Electronic Pressure Relief Valve (EPRV) Delete & Fuel Rail Pressure Sensor Update

Service Category Service Department

Model Years	Models
2018 - 2020	AN/CHU/CXU/GR/GI/PI/MRU/LR/TE

EPRV Delete & FRPS Update

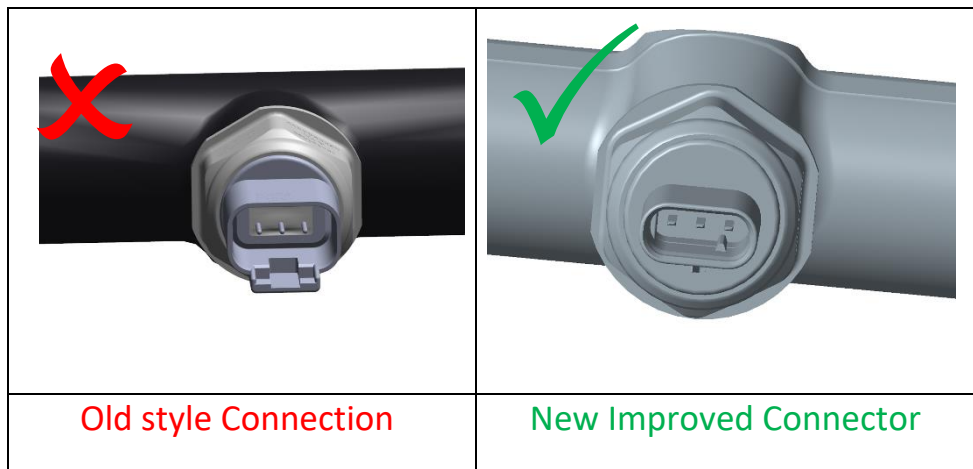
17. A product improvement has been made to the Fuel Rail Pressure Sensor (FRPS) and its wiring harness. A visual inspection of the FRPS electrical connector will indicate which sensor and wiring harness is on the vehicle

18. Inspect the FRPS, if the Old Style Connector is found (Displayed above with red X), replace the sensor and wiring harness per Impact Instructions listed below. If the New Improved Connector is found, no farther action is needed and proceed to next step.
 - a. 2373-03-03-06 Pressure Sensor, Common Rail, Replacement, Valve Cover Removed
 - b. 2861-03-03-03 Wiring Harness, Injector, Replacement (Rear), Valve Cover Removed
19. Refer to IMPACT document ID: 2115-03-02-02 *Valve Cover, Replacement* for valve cover install procedure.
20. Using PTT Operation 1700-22-03-06 Program accessory kit: **85156014**
Note: Running this kit without removing the ePRV will result in adverse vehicle affects.
